**REVISED
ENVIRONMENTAL
IMPACT
STATEMENT**

**KIHEI
DRAINAGE
PROJECT**

*Department of Public Works • County of Maui
April, 1980*

14. RESPONSE TO WRITTEN COMMENTS

FIGURE 4
 PROPOSED KIHEI DRAINAGE PROJECT

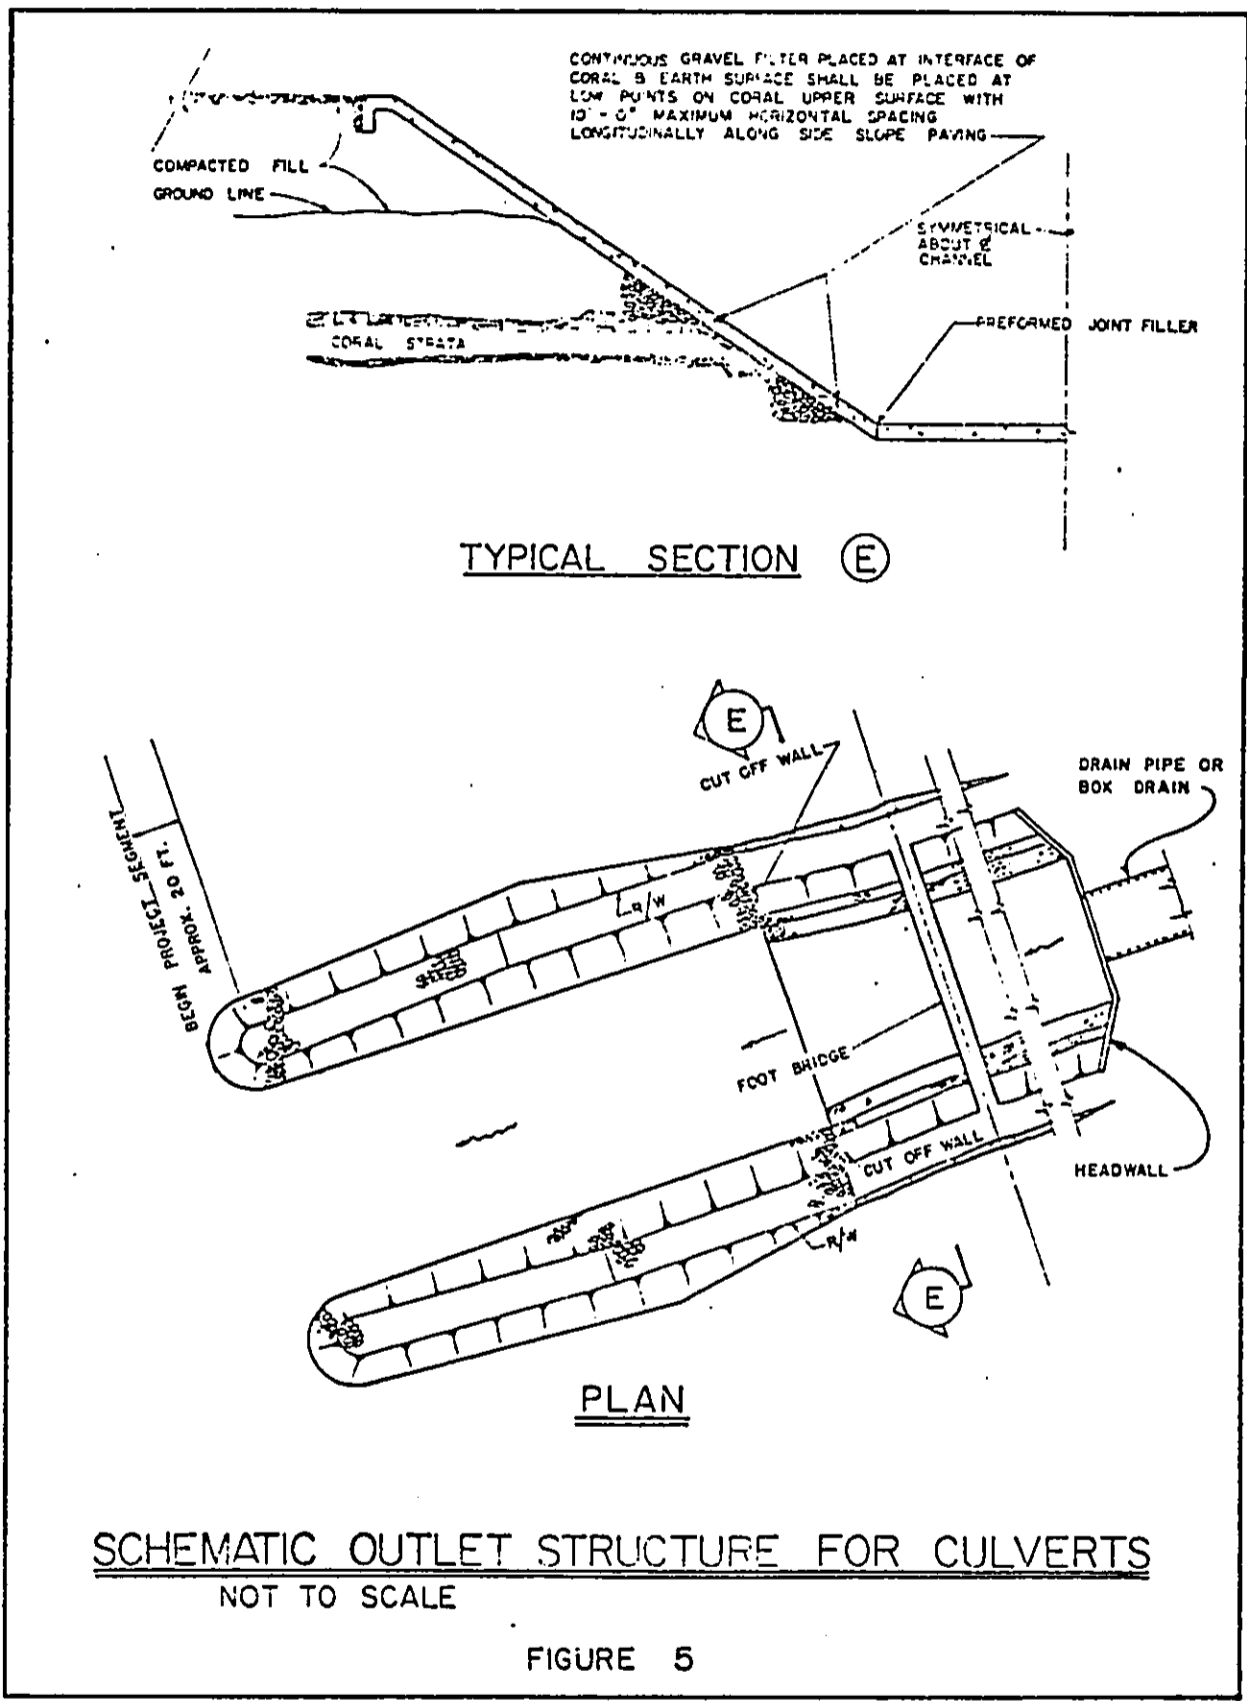
- 1) The alignment of the flood control channels as shown in figure 4 does not coincide with that shown on our copy of the Kihei Civic Development Plan. This is especially so for Keokea Stream where the Plan has a straighter alignment. We recommend a clarification on this topic.

1. The flood control channels as shown in Figure 4 is not the responsibility of the "Kihei Drainage Project." They are channels that are proposed by the U.S. Army Corps of Engineers. The alignments depicted on the Kihei Civic Development Plan were "predicted" drainage lines that eventually may be constructed (Land Use Division - DPED). The "Drainage Master Plan for the County of Maui, 1971, reflects a more accurate plan and alignment. One that is consistent with the Corps' flood control channels (See Figure).
2. The estimated cost will be approximately \$13 million for the project (See Pages 16-17 of the EIS). Engineering cost are assumed to be 4% of the total project costs or \$520,000.00.

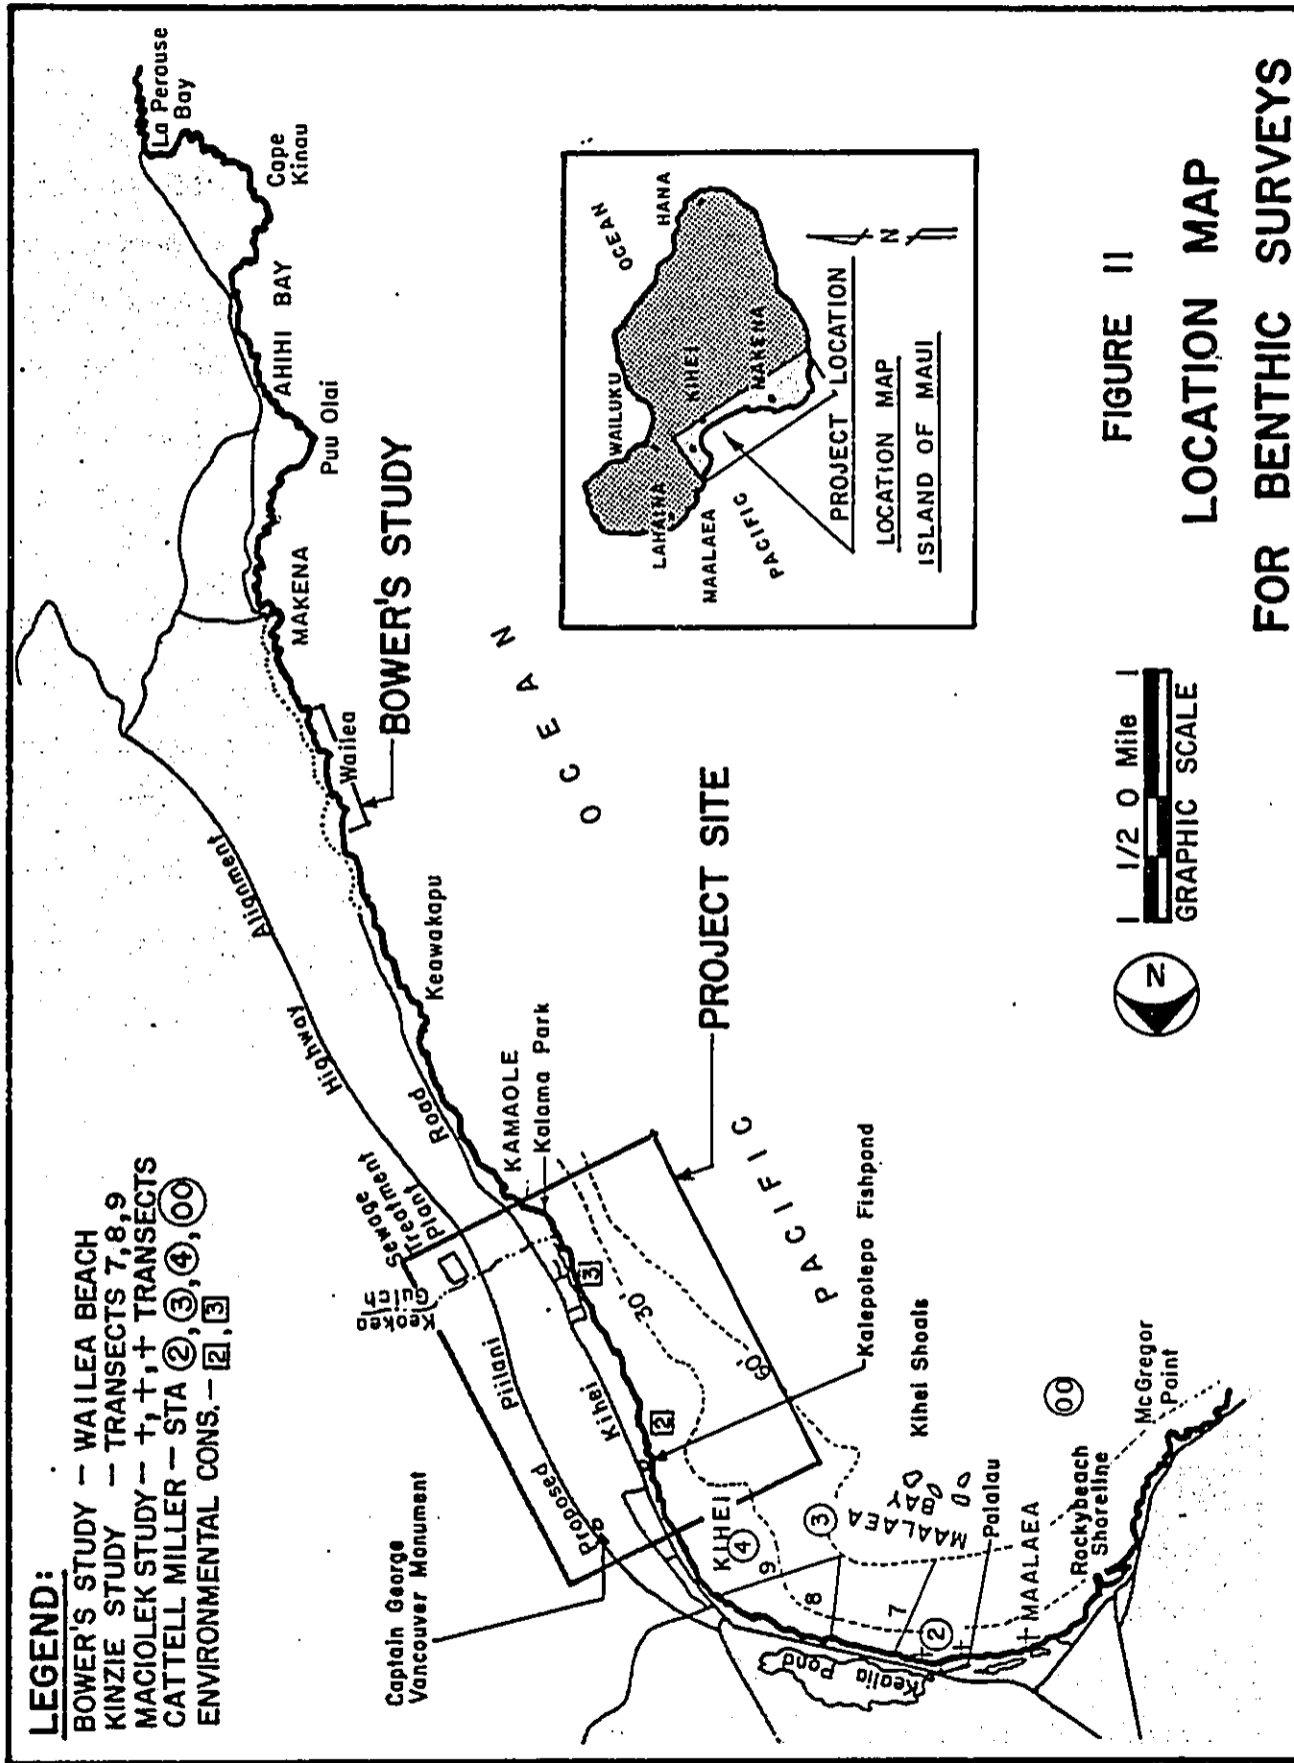
5. Comment: Modify Figure 14 to indicate the locations of the previous marine life survey sites.
Response: The information has been placed on Figure 14. (Changed to Figure 11)
6. Comment: A site specific study of the offshore waters is required to evaluate primary and secondary effects of the project.
Response: A recent survey of the coastal waters off Kihei was conducted and the information acquired is contained in the section entitled, Marine Life, page 29.
7. Comment: Expand "the discussion over construction impacts... to identify protective erosion control measures."
Response: Erosion control measures are discussed on page 85, Mitigation Measures to Minimize Adverse Environmental Impacts.

2. The location of Kealia Pond, relative to the proposed project, has been shown in Figure 11.
3. The locations of the sites, studied by Environmental Consultants, Inc., have been corrected on Figure 11 on page 28 of the EIS. The site locations are shown as numbered squares.

FIGURE 12

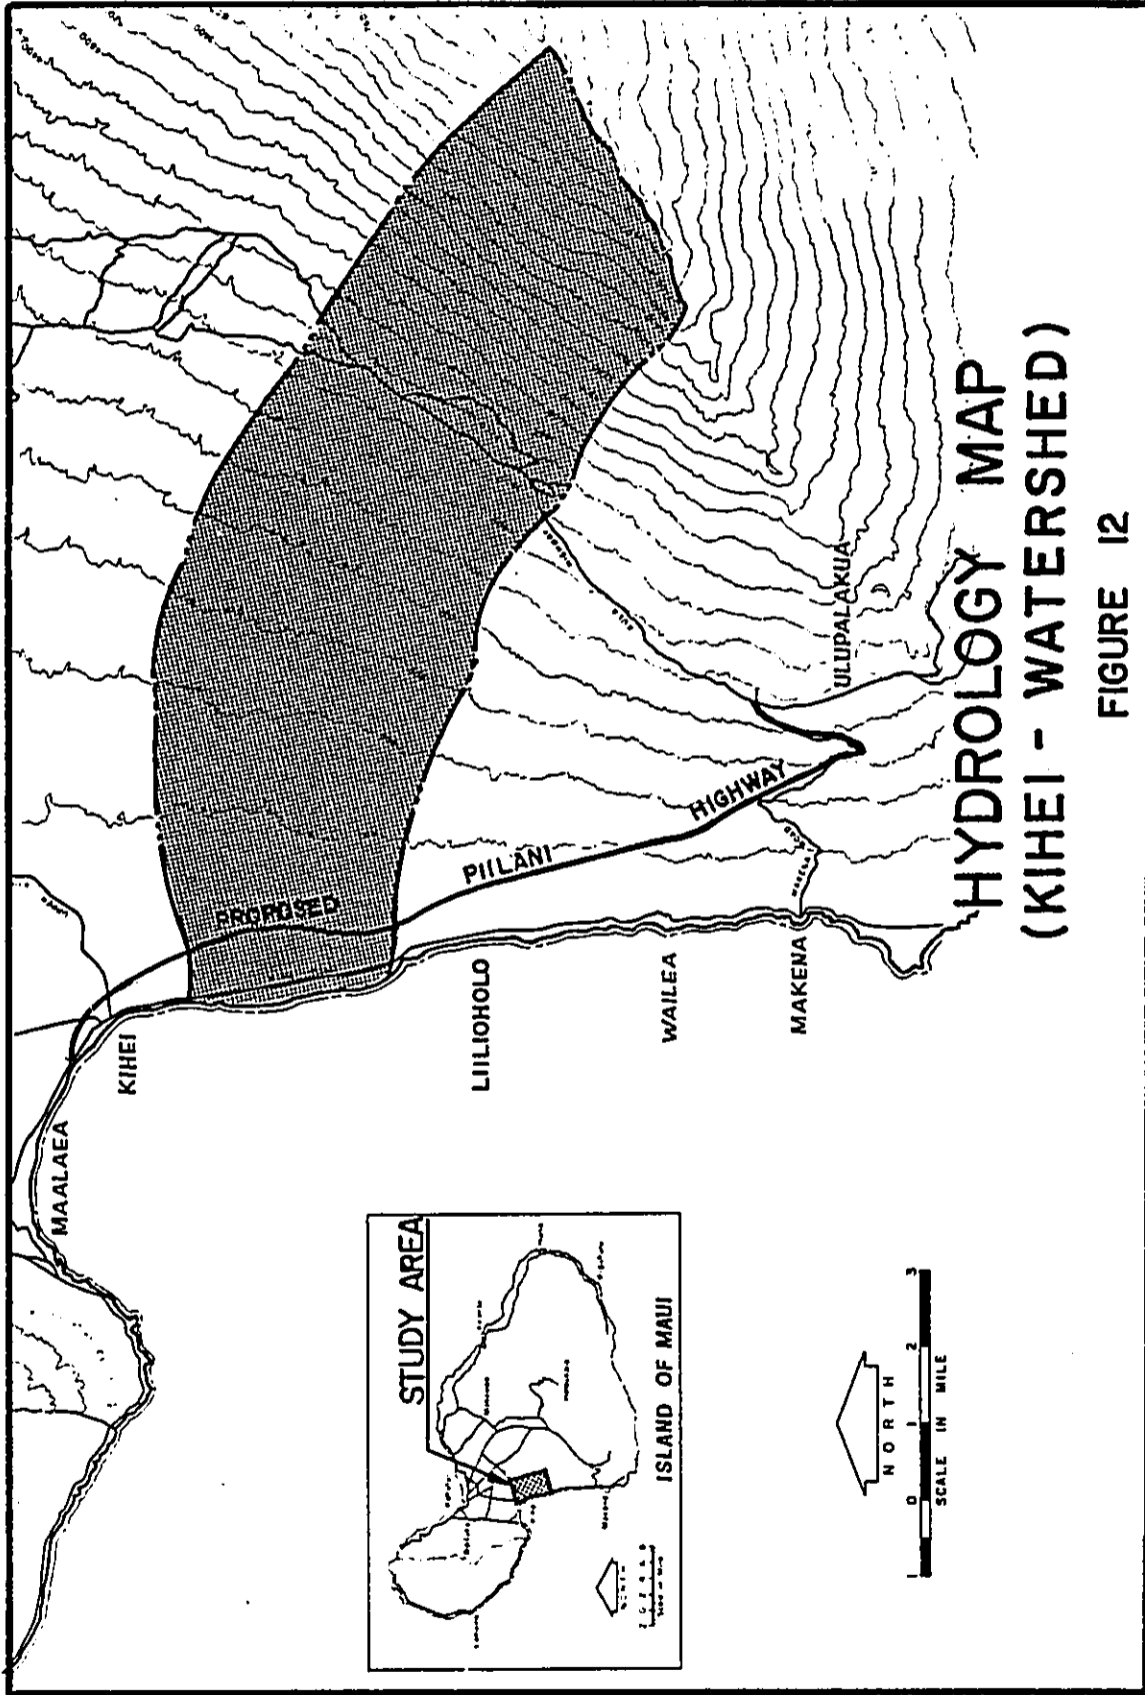
Response: Schematic design details are provided in Figures 5 and 6 and on page 73, Aesthetics.
- 3. Comment:** "...reconcile description of watershed with the description of the project service area."

Response: The descriptions are clarified on page 36, Hydrology and in Figure 12.
- 4. Comment:** Discuss the effect of future development of the watershed.

FIGURE 14

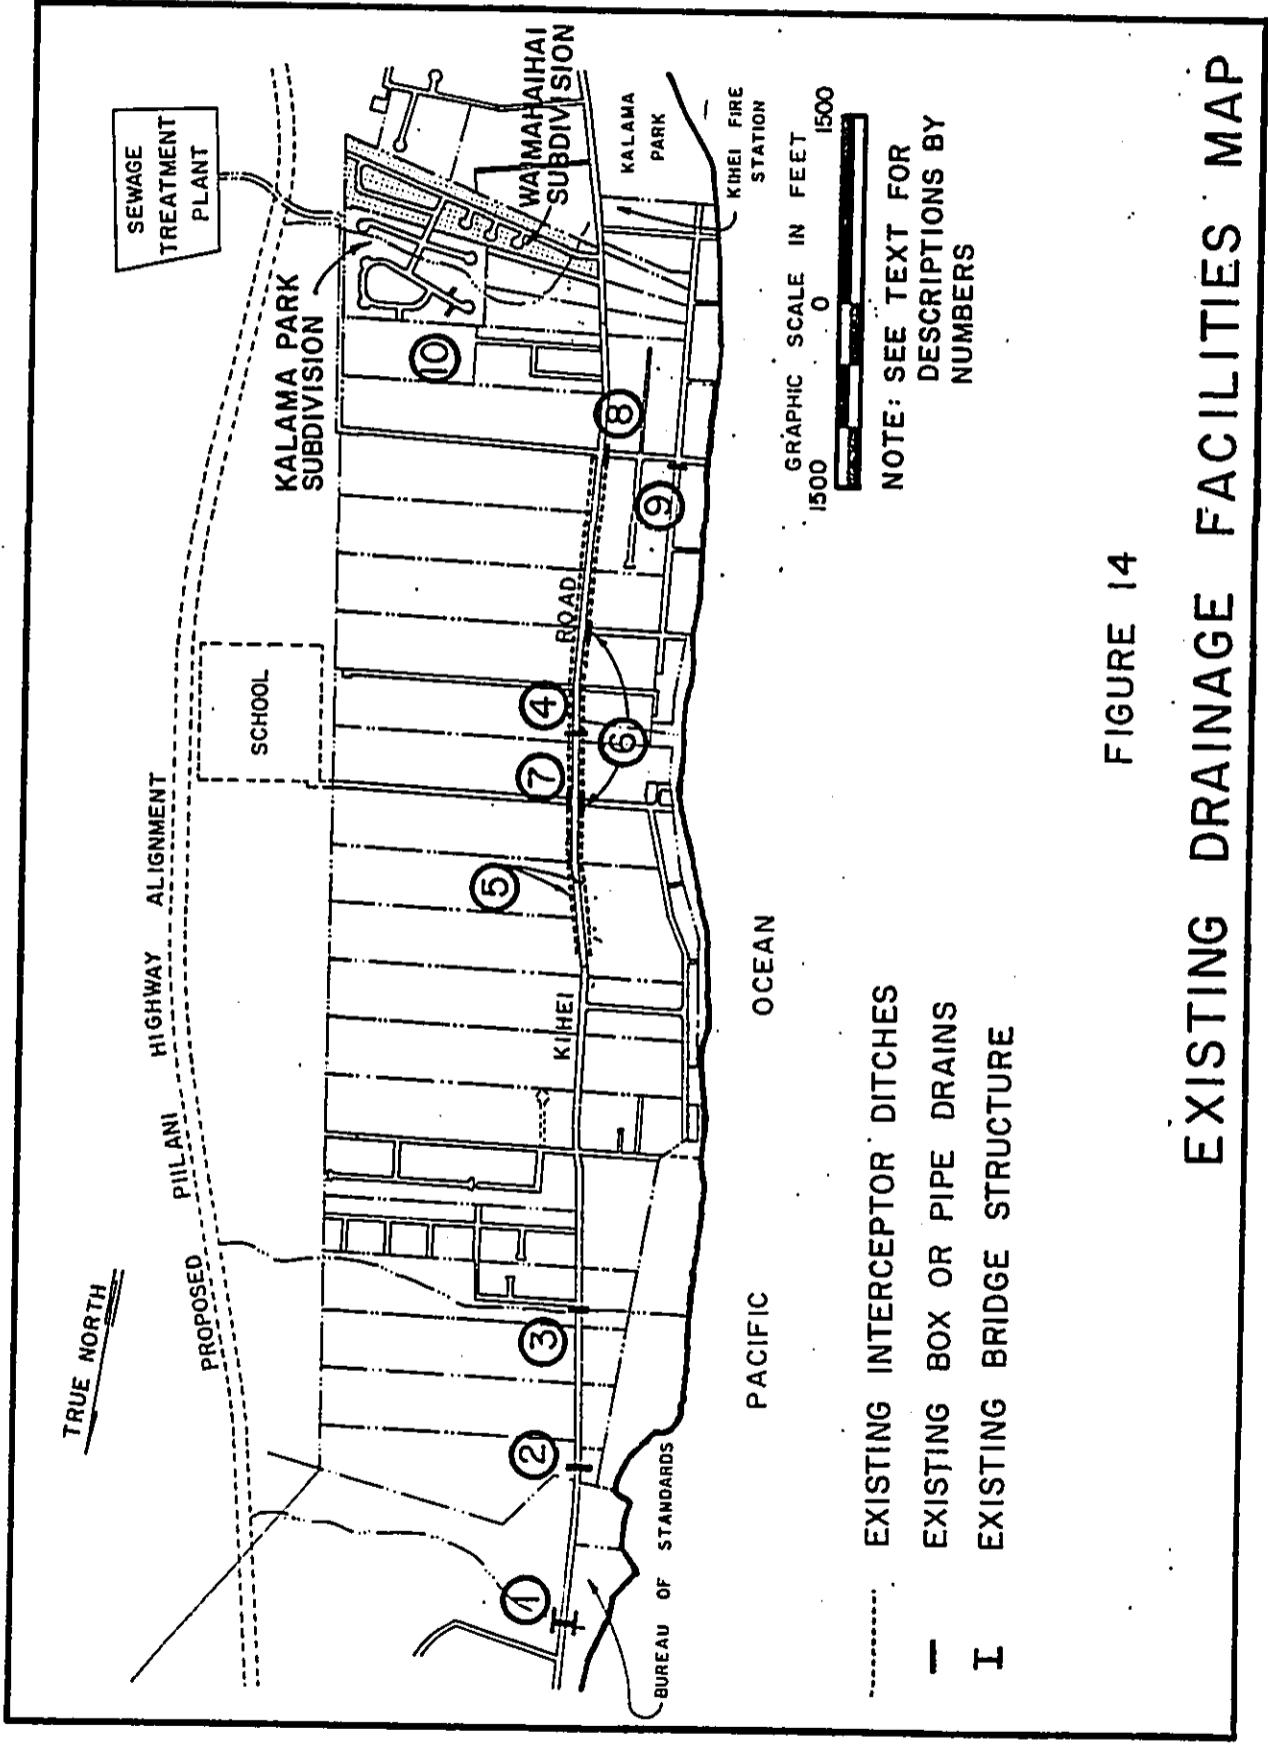
- 5) Page 45. Items a through i should be renumbered 1 through 9 to correspond to their use in figure 14.
- 6) Page 62. Most of the land use/development data appears three to four years old and should be updated.

6. The location of Kalepolepo Fishpond is shown in Figure 11. Items "a" through "i" on pages 47 and 49 have been renumbered 1 through 9 to correspond to their use in Figure 14 on page 46.
